ECE/TRANS/WP.29/GRE/62
4 November 2009

Working Party on Lighting and Light-Signalling

**REPORT OF THE WORKING PARTY ON LIGHTING AND LIGHT-SIGNALLING
ON ITS SIXTY-SECOND SESSION
(Geneva, 6 – 9 October 2009)**

VISIBILITY OF CONSPICUITY MARKINGS TO THE REAR AND
SIDE OF A VEHICLE

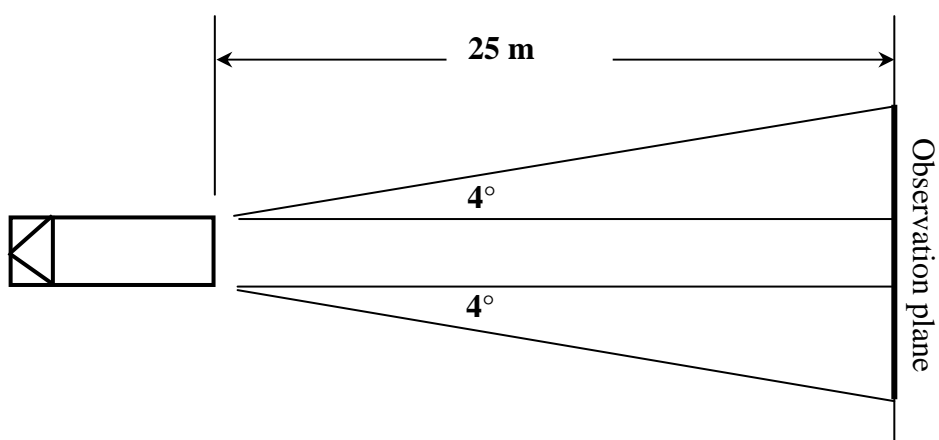
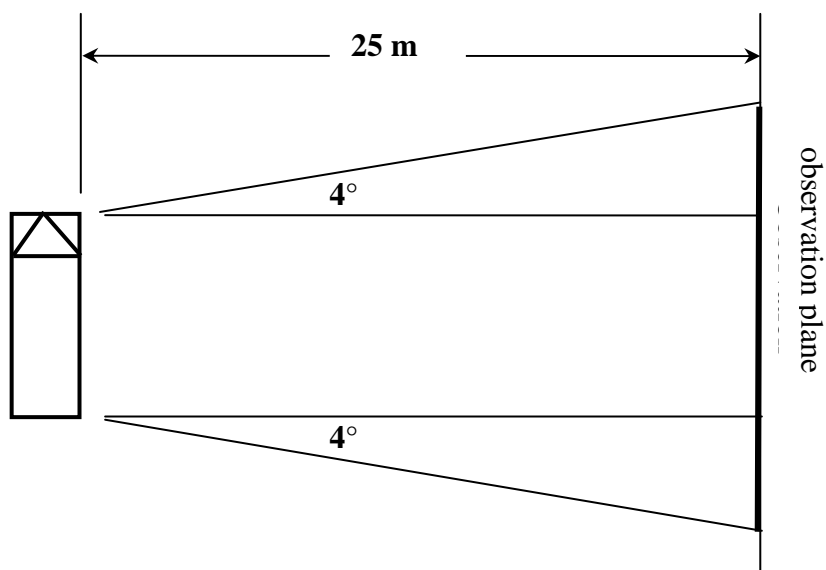
Annex 11, the angles in the figures, for "**15**" read "**4**"

"6.21.5.1.2. in width, by two vertical planes which form an angle of 4° outwards from the vehicle's median longitudinal plane and which pass through the intersection of the vertical planes parallel to the vehicle's median longitudinal plane delimiting the vehicle's overall width, and the plane perpendicular to the longitudinal axis of the vehicle that delimits the end of the vehicle."

6.21.5.2.2. in width, by two vertical planes which form an angle of 4° outwards from a plane perpendicular to the vehicle's longitudinal axis and which pass through the intersection of the vertical planes perpendicular to the vehicle's longitudinal axis delimiting the vehicle's overall length and the extreme outer edge of the vehicle."
